LINCOLN-LANCASTER COUNTY HEALTH DEPARTMENT

Request for Site Clearance and Permit

PROJECT: WHITEHEAD OIL WASTEWATER - SHALLOW TRENCH SYSTEM

SHALLOW TRENCH LEACH FIELD

EXACT ADDRESS	Lincoln-Lancaster County Health Department Division of Environmental Health **Service Request Record**
84TH + Hwy 6	
OWNER Whitehead Oil	COMMENTS
OCCUPANT

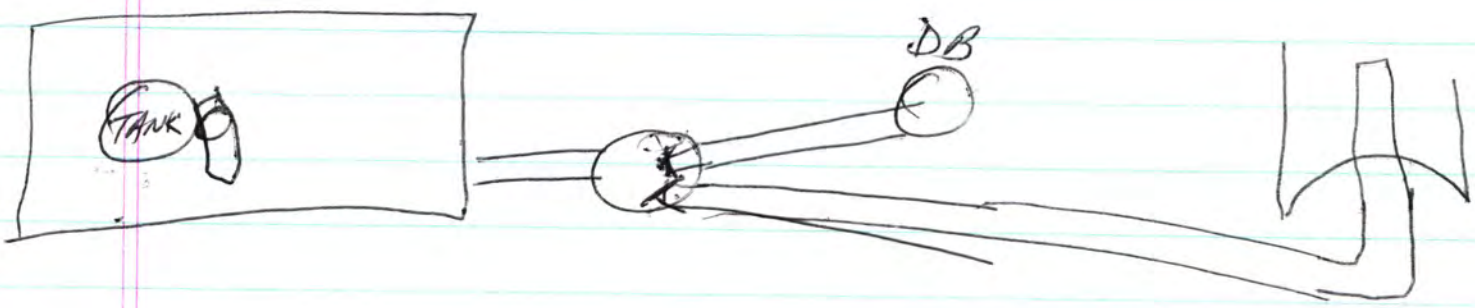
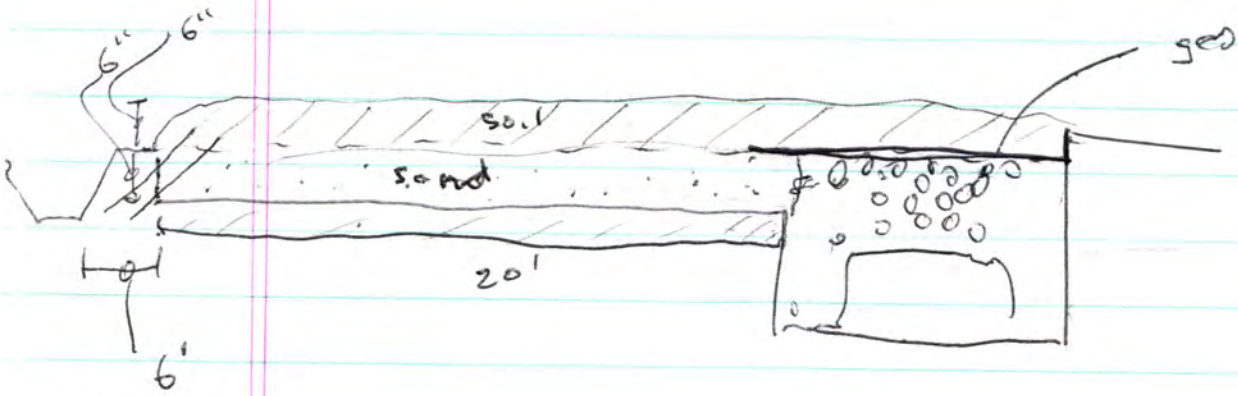
DATE	ACTION TAKEN AND RESULTS	HES
7-31-97	On-site inspection by Ron Marquart of engineer designed system for drainfield disposal of sewage from U-stop at 84th + Hwy #6. Major changes from 6-18-97 drawings of Olsson Assoc. drawing of Shallow trench Leach Field were noted: 1) Seepage bed is 23-30" deep 2) Line from old lateral to distribution box is not plugged. 3.) Line to new seepage bed is perforated and in gravel. 4) New seepage bed is located farther east of old lateral by comparison with drawing location.	
8-12-97	ON SITE VISIT WITH JOHN OLSON, JOHN STROHMEYER, NDEQ + OWNER SEE ATTACHED SKETCH.

1. CAP OFF OLD LINE.
2. DISK BED AREA PRIOR TO APPLICATION OF SAND.
3. DO NOT ROTO TILL.
4. CAP OFF OR PLUG OVERFLOW AT SEPTIC TANK.
5. CONTACT NPPD TO MOUND EARTH UNDER ELECTRIC TOWER.
6. LINE FROM DISTRIBUTION BOX TO BED SHOULD NOT BE PERFORATED.

FORM HD-41(73) APPLICATION FOR PERMIT TO ALTER, EXTEND OR REPAIR INDIVIDUAL SEWAGE DISPOSAL SYSTEM

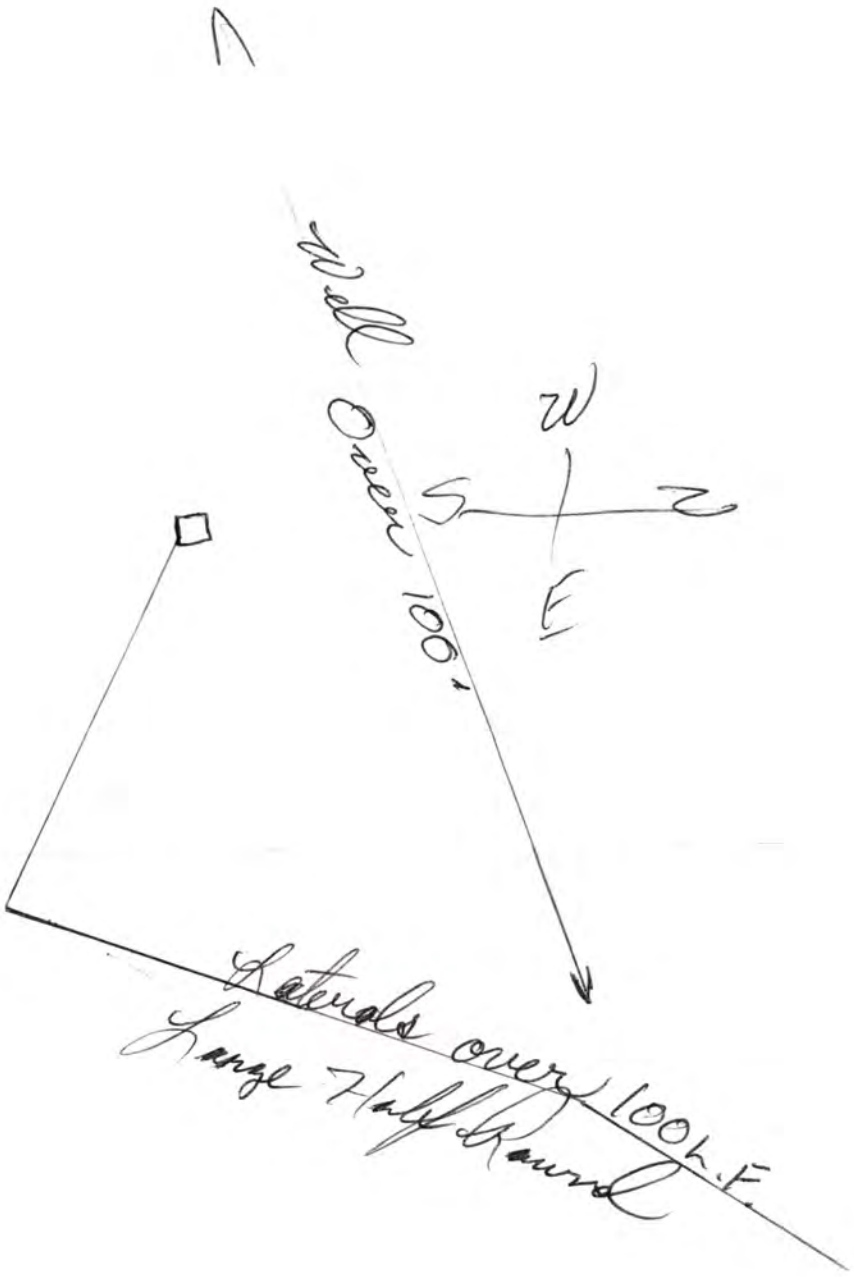
X In flood plain.

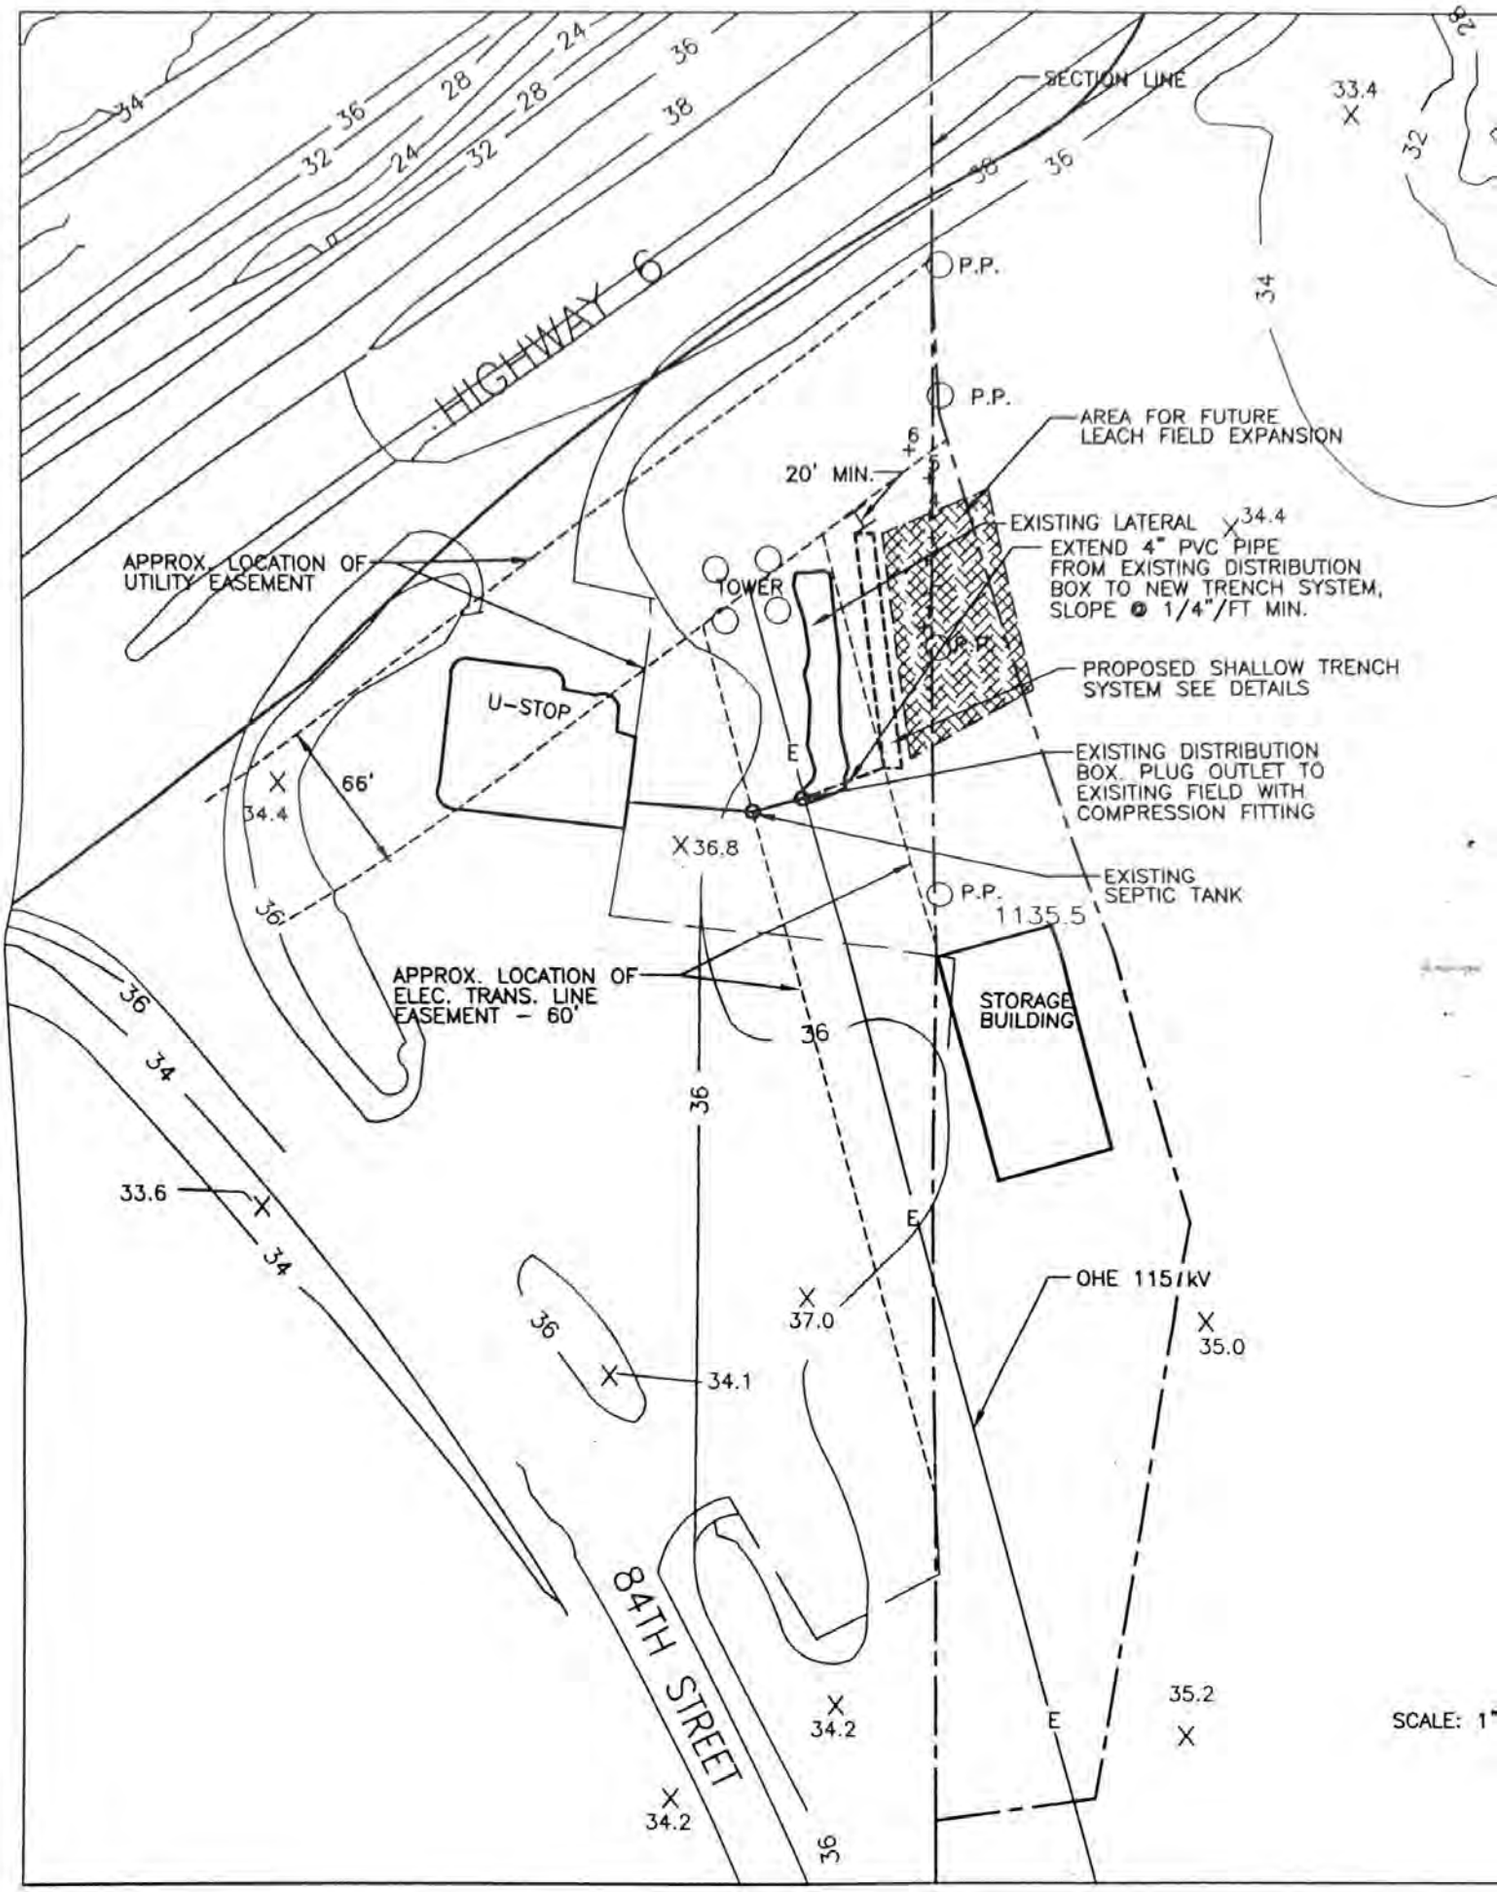
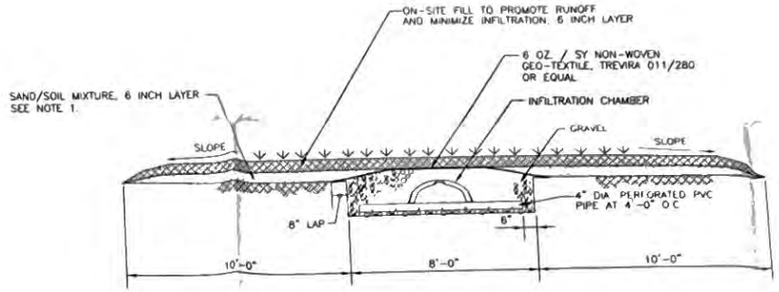
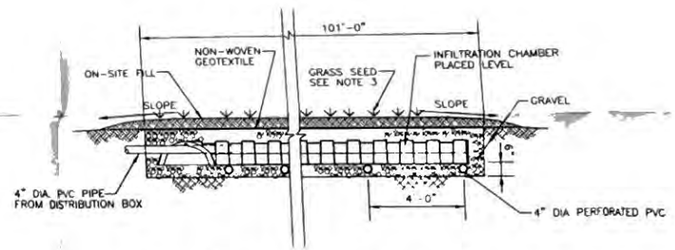
7-31-97, Seepage bed is 23-30" loops approx. 200 ft from bank of Stevens Creek. Line to old lateral is not plugged. Line to new bed is perforated pipe in gravel.
